MONTGOMERY COUNTY PLANNING DEPARTMENT
THE MARYLAND-NATIONAL CAPITAL PARK AND PLANNING COMMISSION

MEMORANDUM

REVIEW TYPE: Preliminary Plan of Subdivision

PROJECT NAME: Brooke Park
CASE #: 120100030
REVIEW BASIS: Chapter 50, Montgomery County Subdivision Regulations

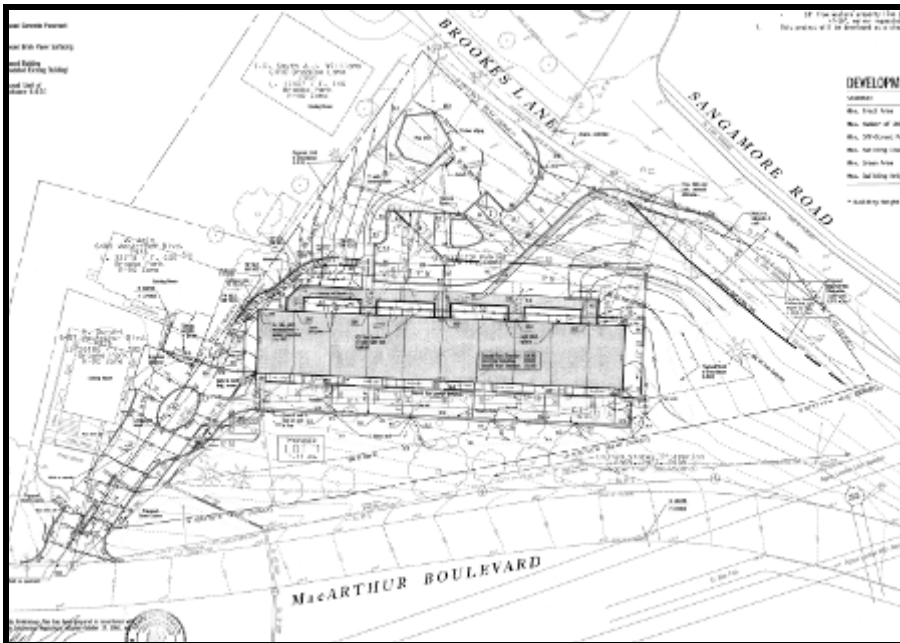
Of particular concern with the original version of the plan was a driveway that looped from the northern side of the building to the southern side around the eastern end of the building. This driveway required significant grading to the steeper slopes of the site, and it also required removal of some of the trees between the building and MacArthur Boulevard. The Applicant addressed this concern by working with the adjacent neighbors to use and modify an existing driveway used by the two residential properties to the west. Access to the southern side of the building will be accommodated with this driveway rather than constructing the more environmentally damaging alternative. Further discussion of the access point from MacArthur Boulevard is provided below.

Staff believes that the applicant revised their plan to address the recommendations of staff and that the use proposed conforms to the recommendations within the Bethesda-Chevy Chase Master Plan.

SKETCH DRAWING
OF THE
PROPOSED EASEMENT
THROUGH THE
HUDA DURANT PROPERTY
LIBER 26106 at FOLIO 182
MONTGOMERY COUNTY, MARYLAND

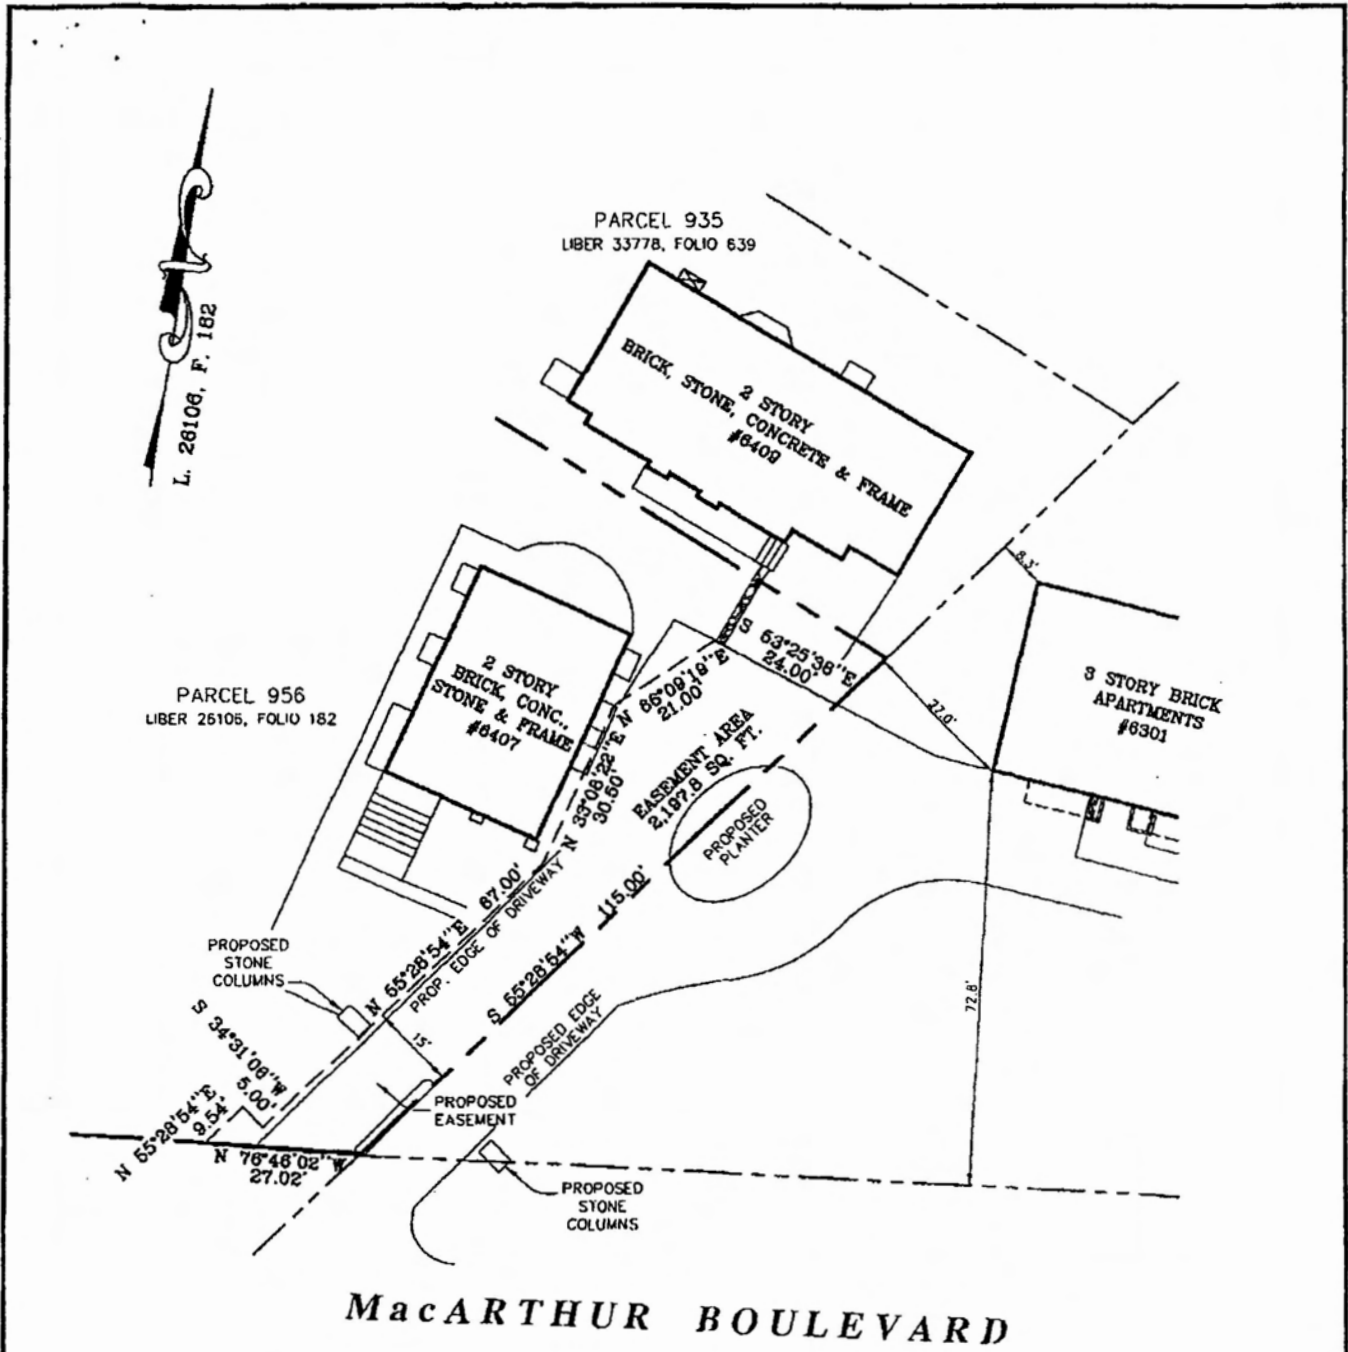
We have reviewed the preliminary plans and concur with the sidewalk plans located on Corps property. However, the plan for the reconfiguration of the driveway may conflict with the grantees of the easements named above. Although the proposed driveway is acceptable as to the operation of Washington Aqueduct, we are not at liberty to approve the reconfiguration of the drive without concurrence of the current easement grantees and proper revision of the easements. We need to know if the current easements are to be transferred, terminated, or should have the applicant added as a joint tenant, as approved by the current grantees.
